Service Bulletin

Red Cam Adaptable and Dual Adaptable Venders

SUBJECT: Vend Motor Assembly with original Linkage Arm - C179,070,600.13.

EFFECTIVE: Serial Number 0381 2506AG
Approximate Date 2/18/82

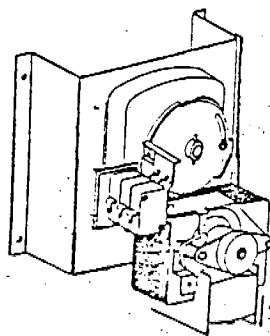
REASON: Since the diameter of the pin on the oscillator has been increased, then the ID of one of the holes in the linkage arm has been increased also.

Vend Motor assemblies will continue to be shipped with the original linkage arm. So that the Vend Motor will adapt to any Red Cam Vender, the revised linkage arm will be included but not installed.

1	A801,201,030.01	Linkage Arm-Revised
1	801,804,770.01	Nyliner-Revised
1	801,803,160.01	Nyliner-(No Change Made)

CAUTION: Make sure the Linkage Arm is compatible with the pin of the oscillator.
